Note:

This document, prepared by Japan, identifies those areas of the gtr text that require review by the informal group. It has been prepared on the basis of the group's declared objective to identify a single dummy that is acceptable to all. If this objective cannot be achieved the informal group will modify the drafting recommendations to provide for the insertion of a second dummy to be used as an alternative to the Hybrid III (leaving the current Hybrid III relevant text unchanged).

Figure 9-1 Spine curvature check

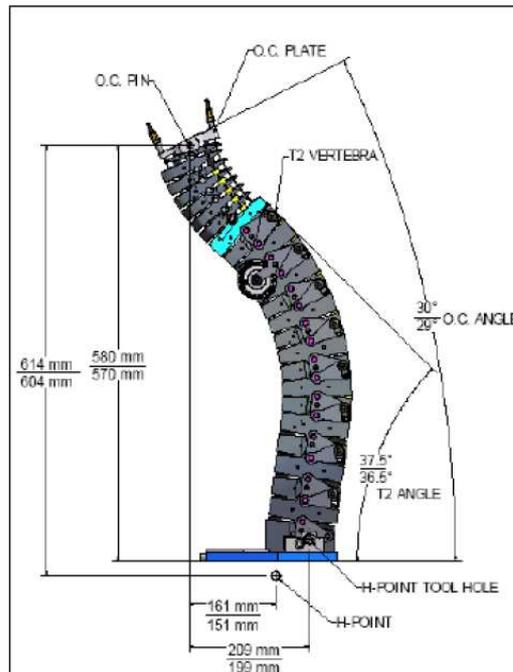
With the pelvis adapter plate placed on a level surface, the spine stature shall meet the specifications defined in Table 9-1 and Figure 9-1. The curvature check shall be performed after every 15 tests and all measurements shall be recorded and fully documented.

Measurement	Specification
Angle of occipital interface plate relative to horizontal	29.5±0.5 degrees
Angle of T2 vertebra relative to horizontal	37.0±0.5 degrees
Angle of neck plate (lateral)	0±0.5 degrees
H-point indicator to occipital condyle pin (horizontal)	156±5mm
H-point indicator to occipital condyle pin (vertical)	609±5mm

Figure 9-3 Impact Waveform and Permissible Range of Waveform

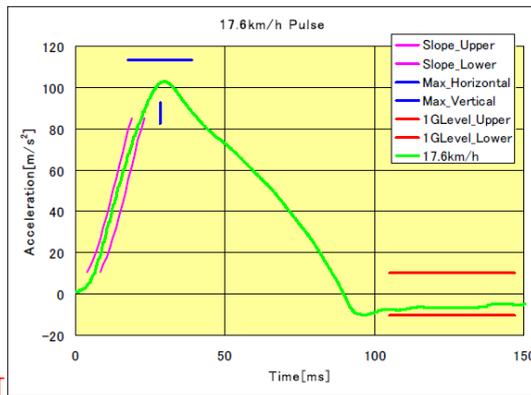
4.1. The corridors for the pulse are illustrated in Figure 9-3. The sled acceleration shall be adjusted within the corridors in Table 9-2 for the complete time interval from 0 to 0.15s. The sled pulse shall fulfil the requirements as specified in Table 9-3.

Definition	Tolerance	Unit
Velocity change	ΔV	17.6	± 0.9	km/h
Duration	ΔT	90.0	± 5.0	ms
Mean acceleration	Mean Acceleration	54.3	± 5.0	m/s ²
T=0 acceleration	AT0	0.0	± 3.0	m/s ²
